MIL-C-16173D  
AMENDMENT-2  
19 November 1968  
SUPERSEDING ✓  
AMENDMENT-1  
17 March 1967

CORROSION PREVENTIVE COMPOUND,  
SOLVENT CUTBACK, COLD-APPLICATION

This amendment forms a part of Military Specification MIL-C-16173D, dated 20 October 1966, and is mandatory for use by all Departments and Agencies of the Department of Defense.

Figure 8 - Hot water - low pressure steam removability apparatus.

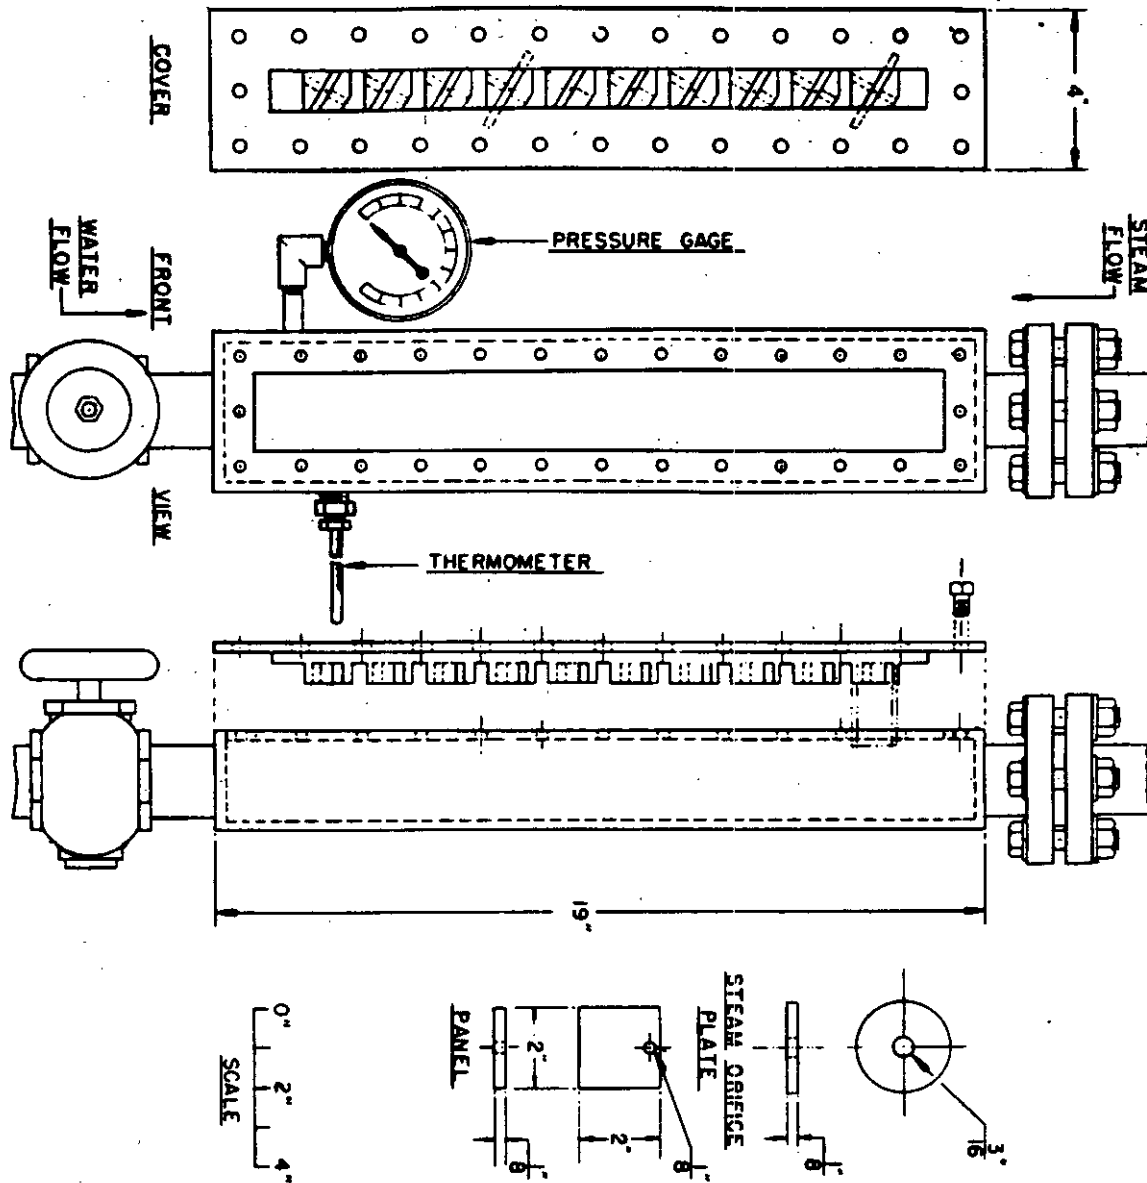
Add the attached figure 8.
